SUBJECT: Robbins Library Exterior Envelope Repairs/
Phase 1A

ADDENDUM NO. 2

ROBBINS LIBRARY EXTERIOR ENVELOPE REPAIRS -PHASE 1A
BID NO. 19-58
ARLINGTON, MASSACHUSETTS
CBI JOB NO.: 17152- A

Project: ROBBINS LIBRARY
EXTERIOR ENVELOPE REPAIRS – PHASE 1A
700 MASSACHUSETTS AVENUE
TOWN OF ARLINGTON, MASSACHUSETTS,
BID NO. 19-58
CBI JOB NO.: 17152-A

A2-04

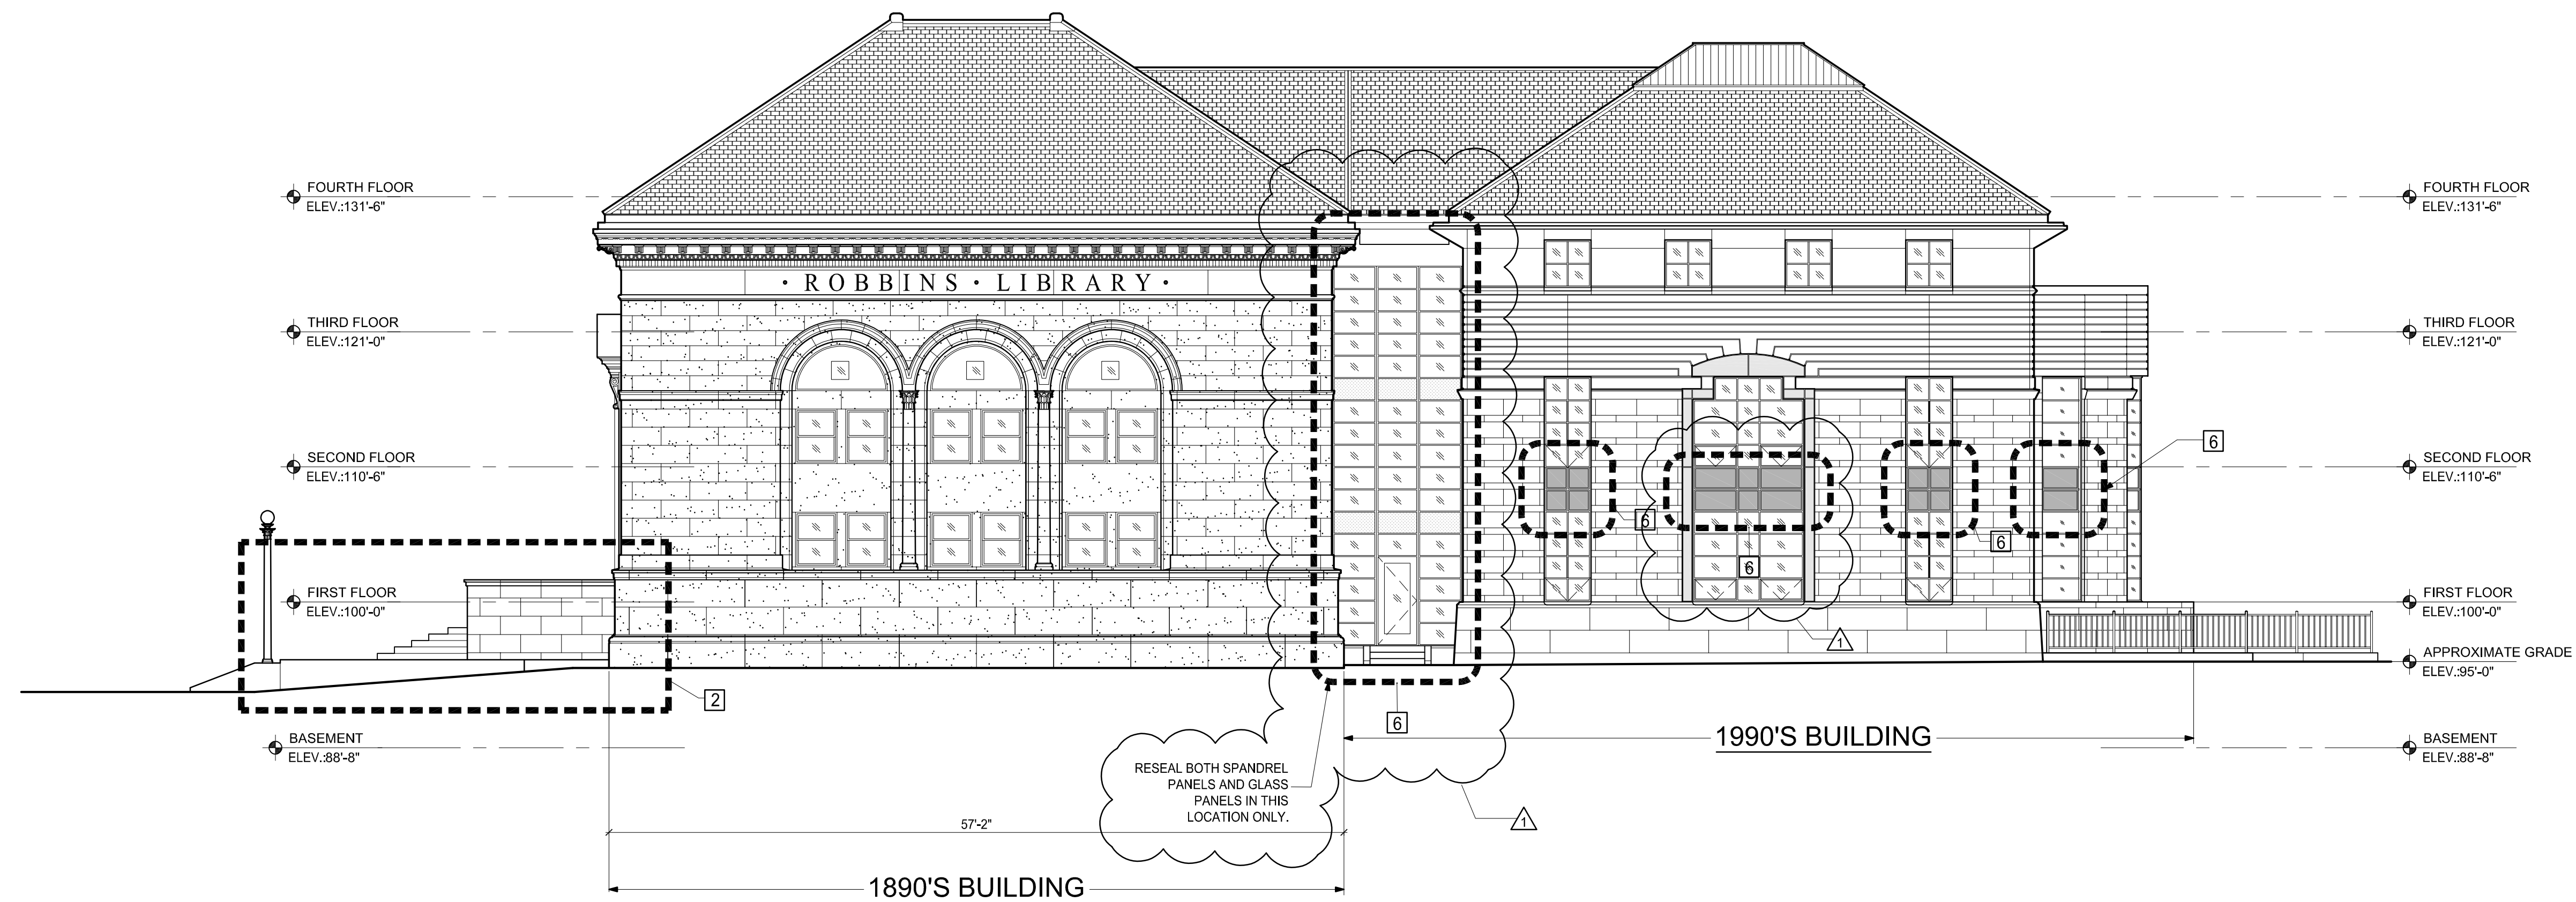
- 1.3 QUESTION...Can we assume Repair and Restoration Work Note #6 is referring to detail 7a and 7b on A4-01?

1.4 QUESTION...Does the limit of work for Note #6 shown on the West Elevation include the complete perimeter of the glass panels above and below the aluminum panels?

ANSWER...For Note #6, delete reference to Details 8A & 8B, and change to Details 7A & 7B on Sheet A4-01. Refer to enclosed Drawing Sheet A2-04 (Revision 1 dated 12-02-2019).

ANSWER...The only glass panels requiring resealing are located on the North Elevation. Refer to enclosed Drawing Sheet A2-04 (Revision 1 dated 12-02-2019).

6. RE-SEAL EXISTING ALUMINUM SPANDREL PANELS, AS IDENTIFIED AT 1990'S BUILDING. SEE DETAIL 7a & 7b / A4-01. THE WORK ALSO INCLUDES RESEALING THE GLASS PANELS AT THE NORTH ELEVATION, AS NOTED
